Paradise Business Centre

Lot 1, Block 1,
Paradise Valley Second Addition

Buildings 1, 2, 3, & 4

Revision Schedule		
△	Addendum	01/03/2025
△	Addendum	01/14/2025

COVER SHEET

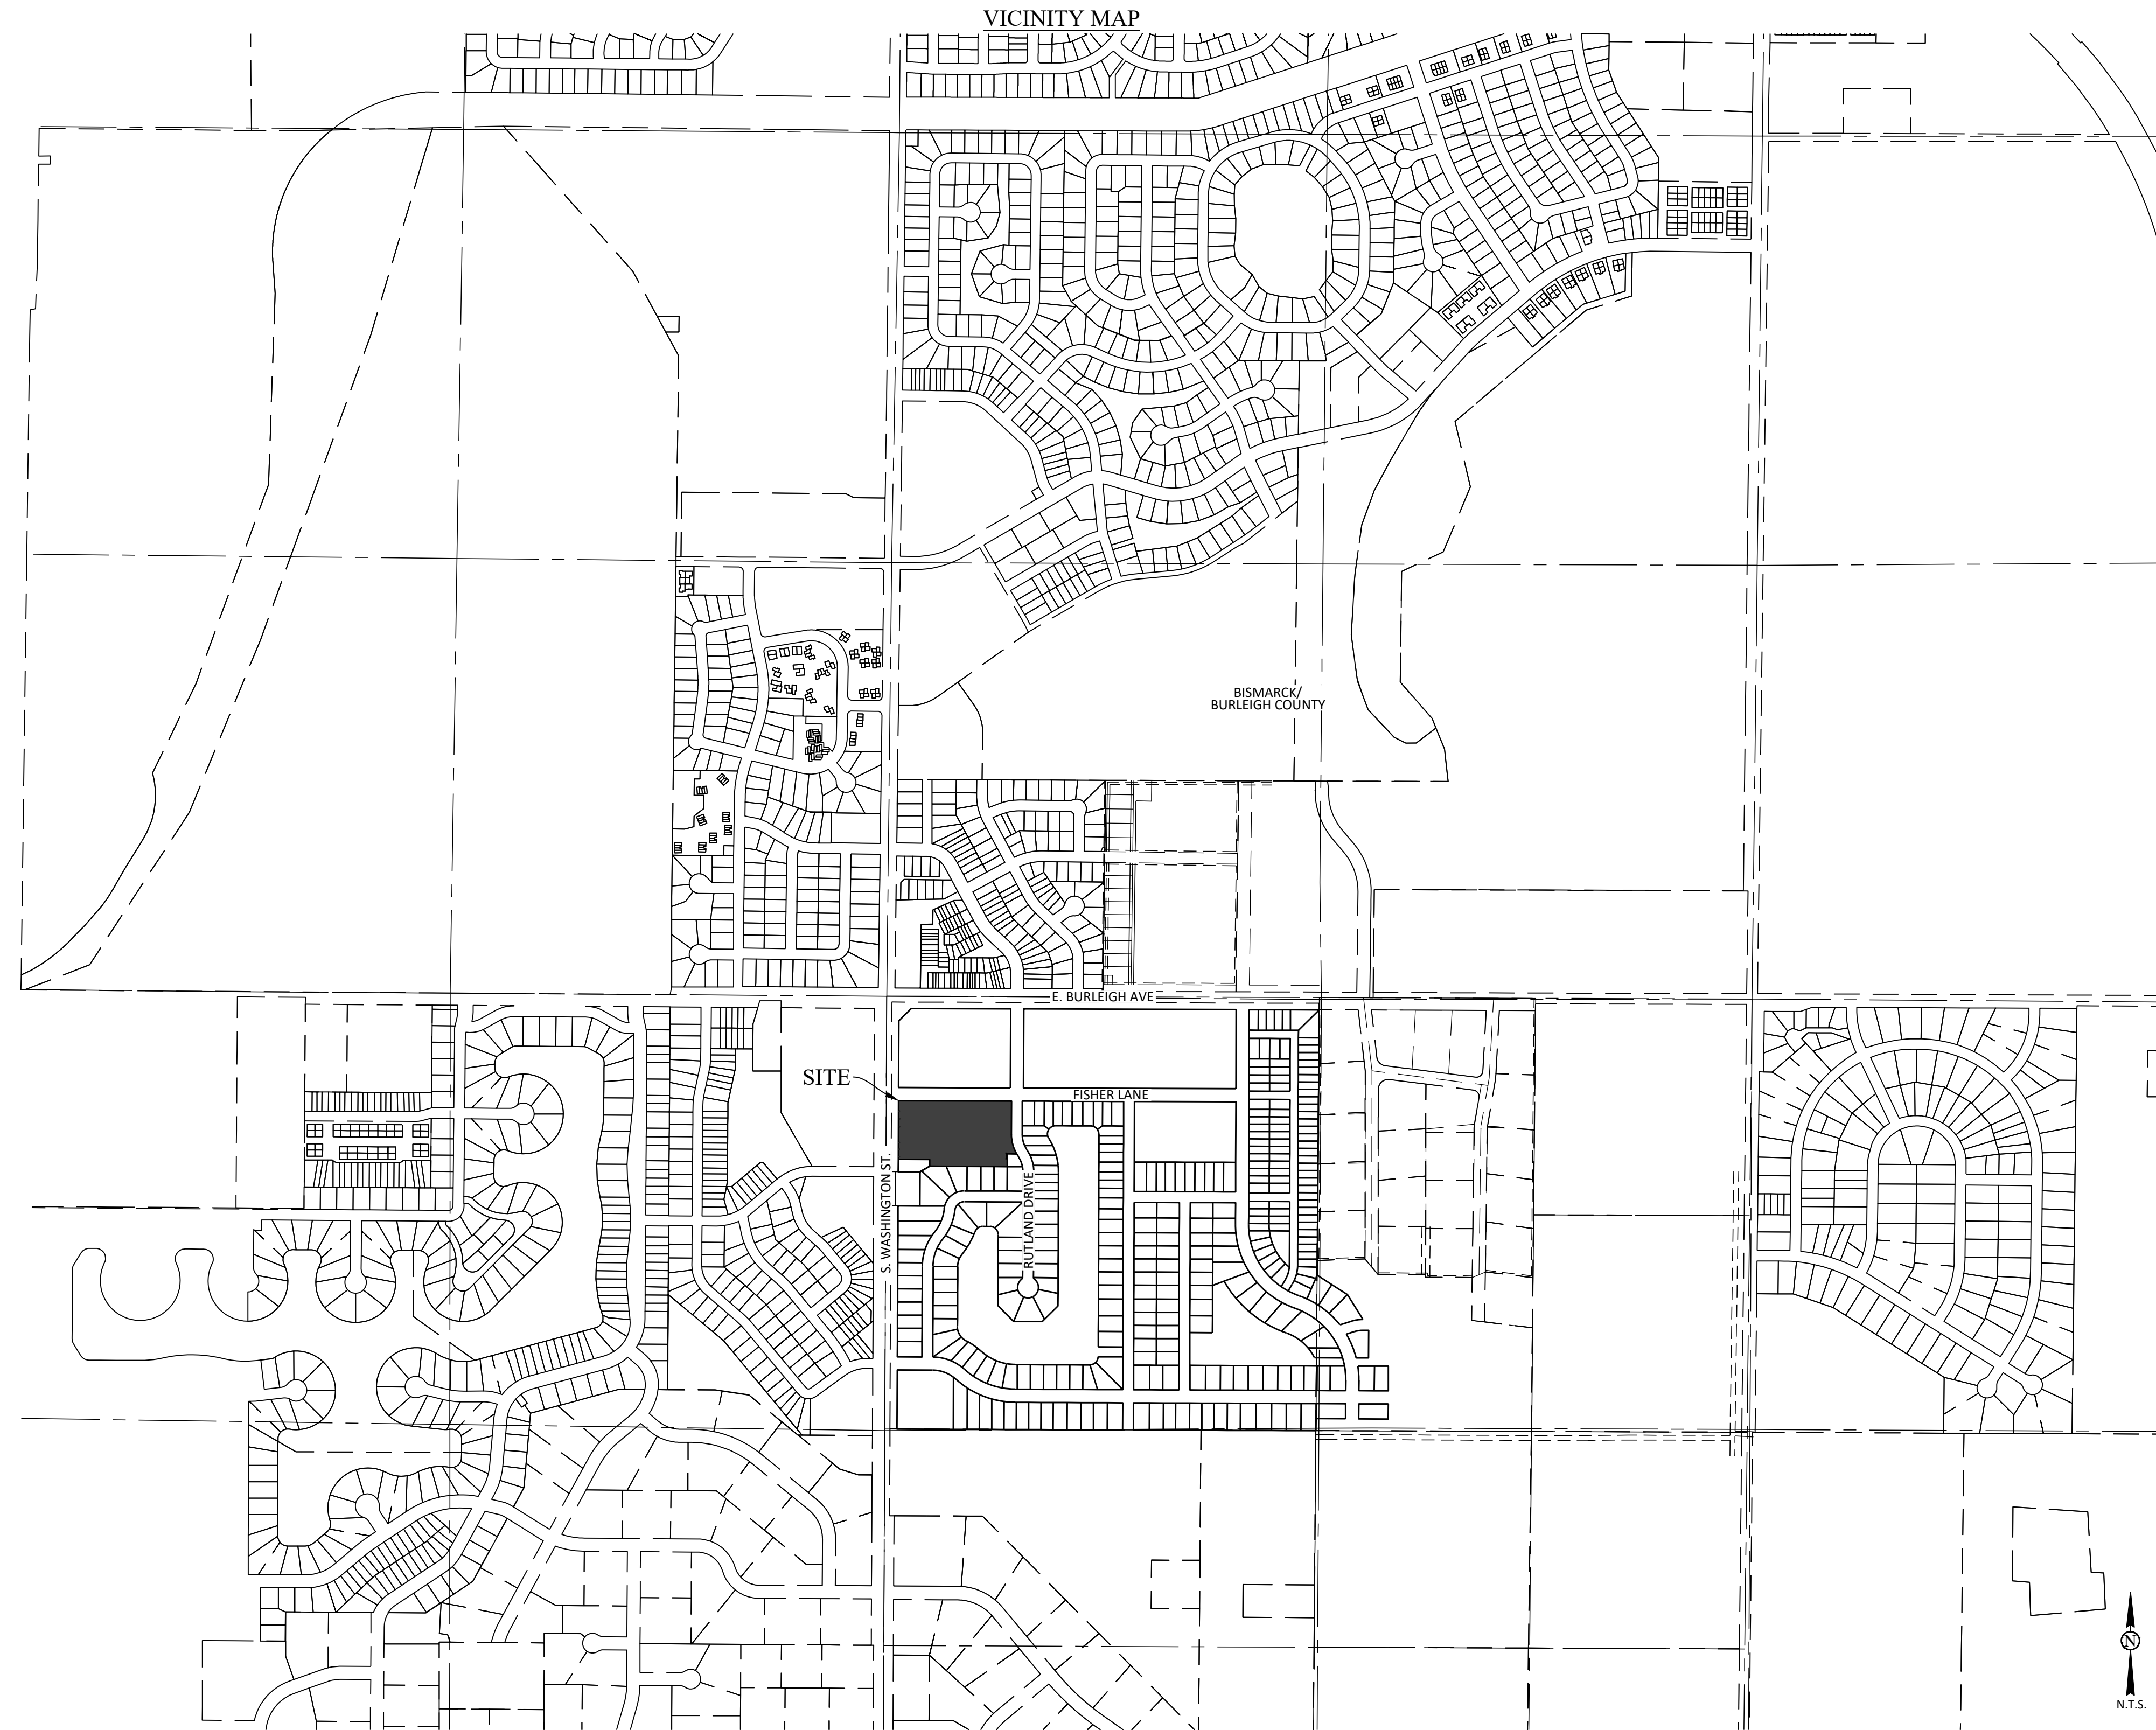
REVISIONS PER CITY COMMENTS
- UPDATE PARKING COUNT PER LAYOUT REVISIONS.

SURVEY OVERLAY
&
DEMOLITION PLAN

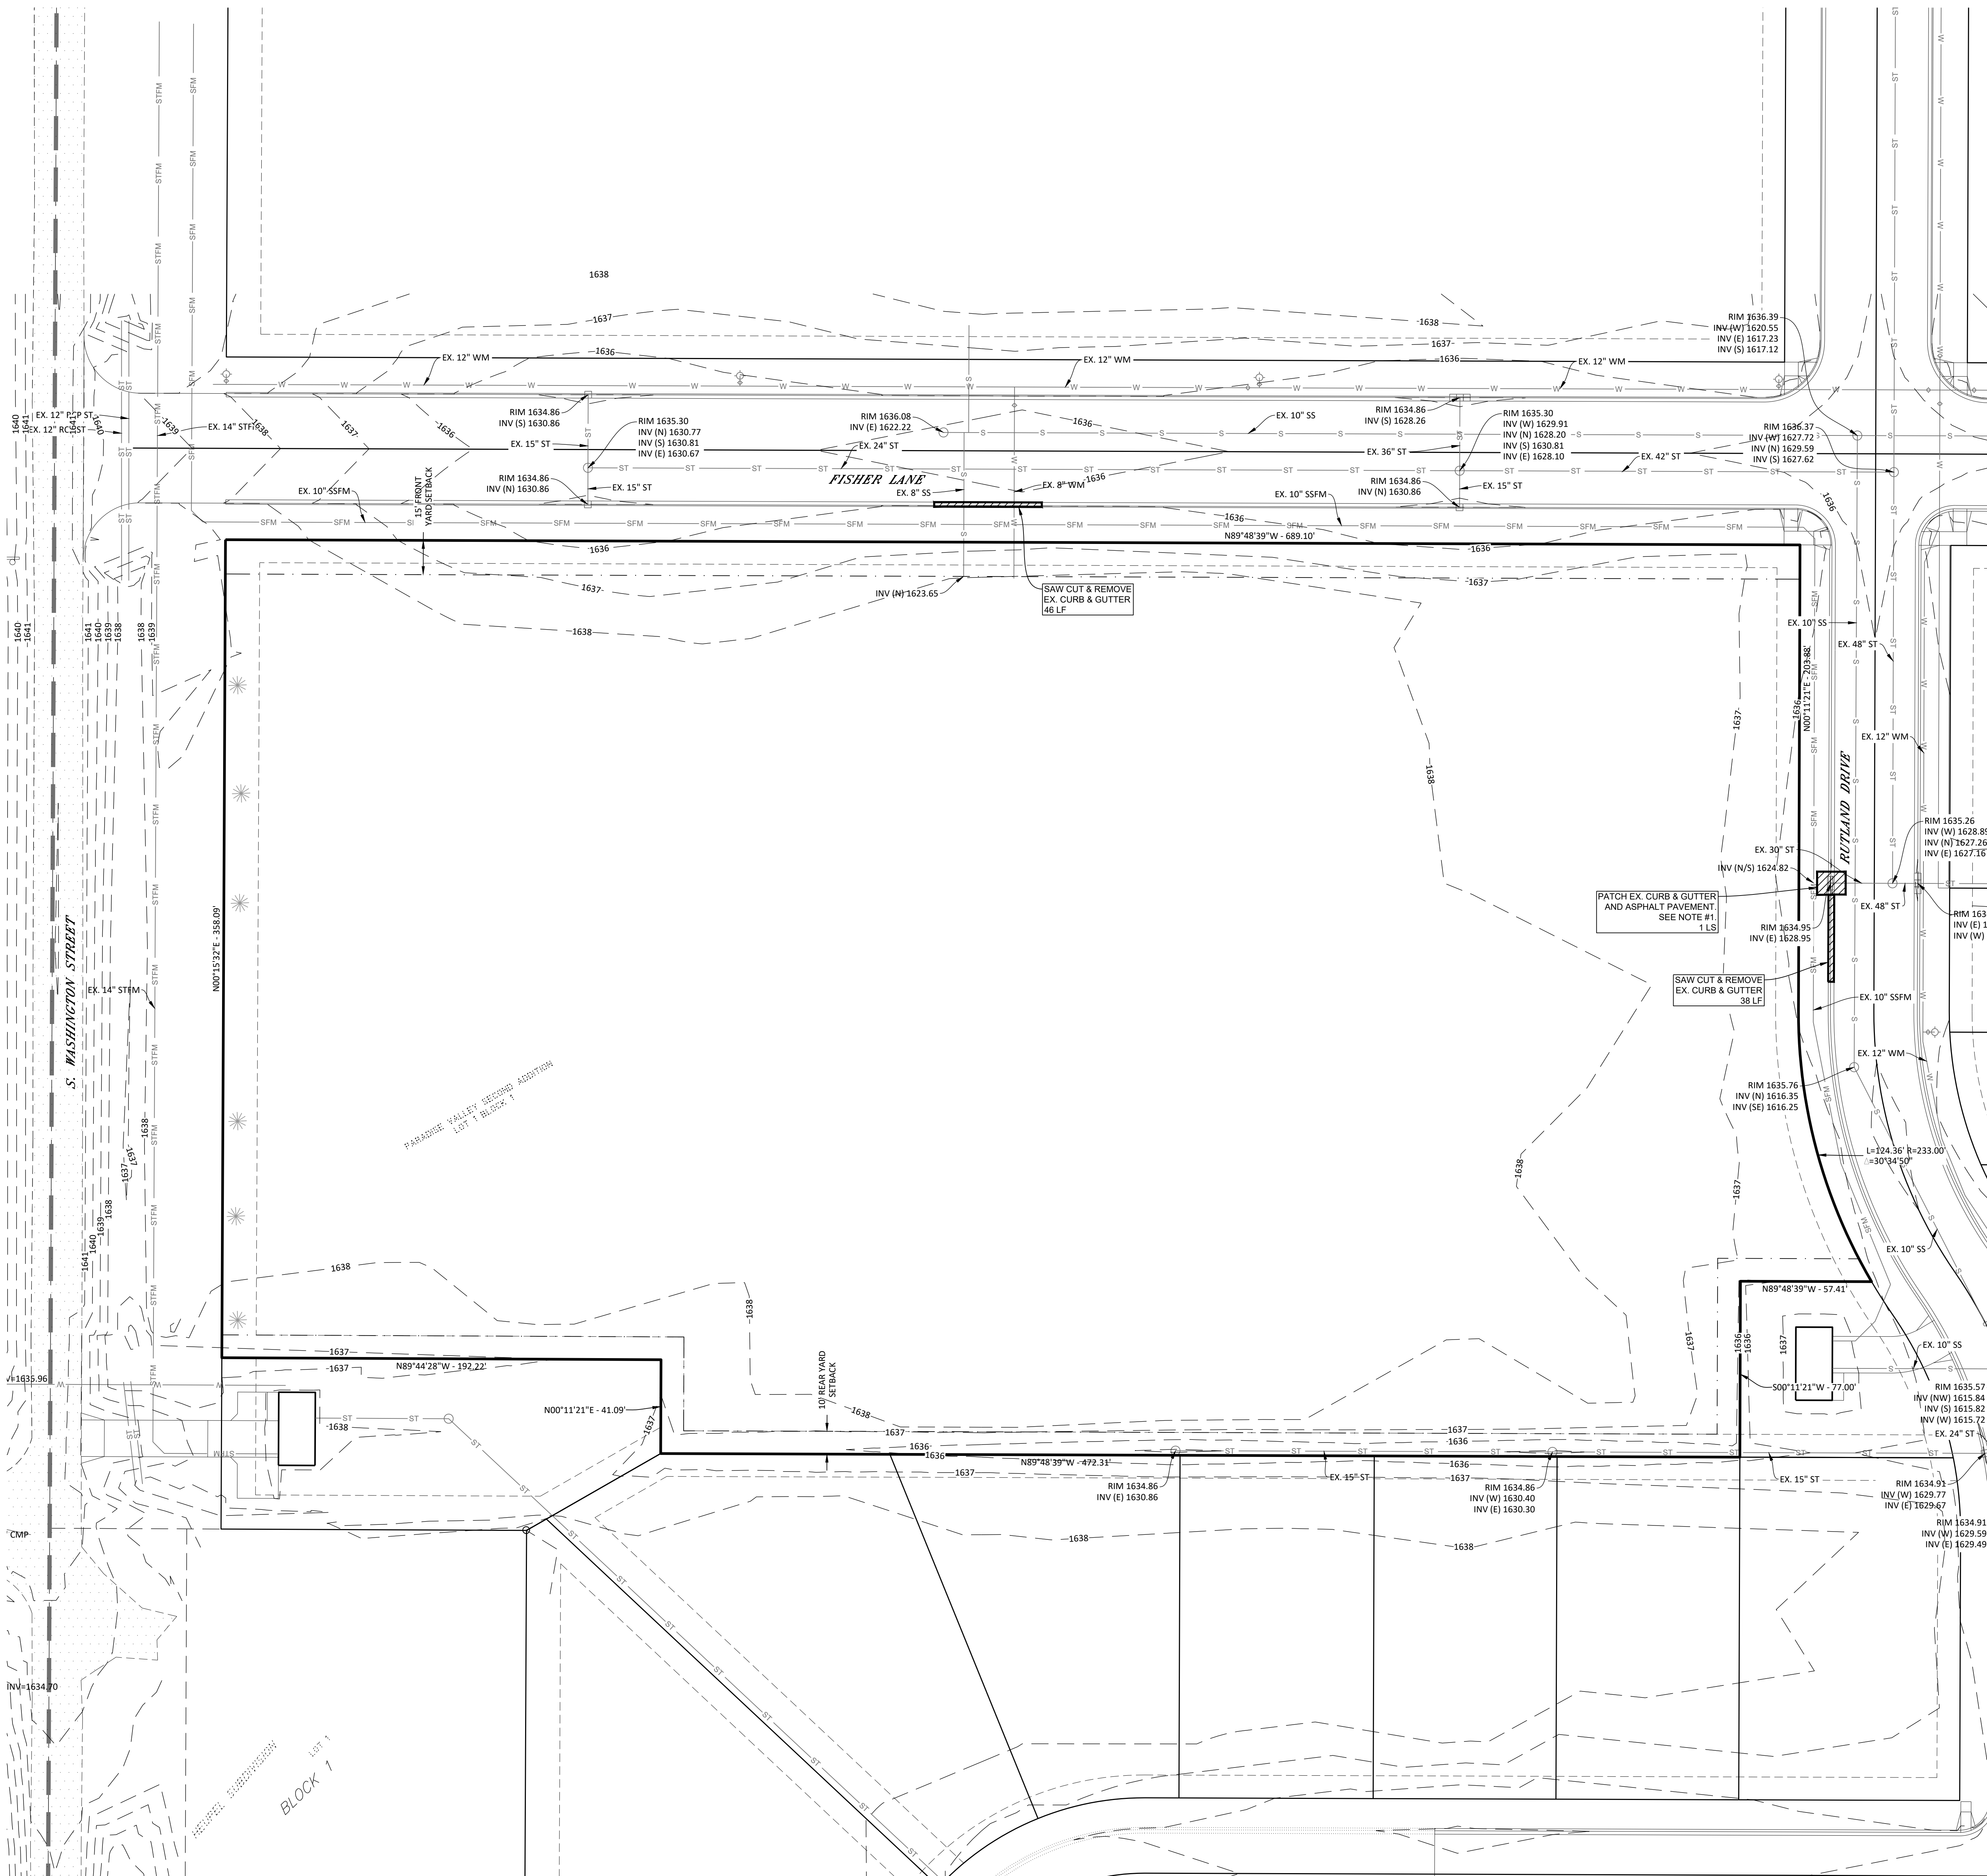
REVISIONS PER CITY COMMENTS
-ADJUST CURB & GUTTER REMOVAL AND PATCH ITEM ON EAST SIDE OF PROPERTY IN RUTLAND DRIVE.
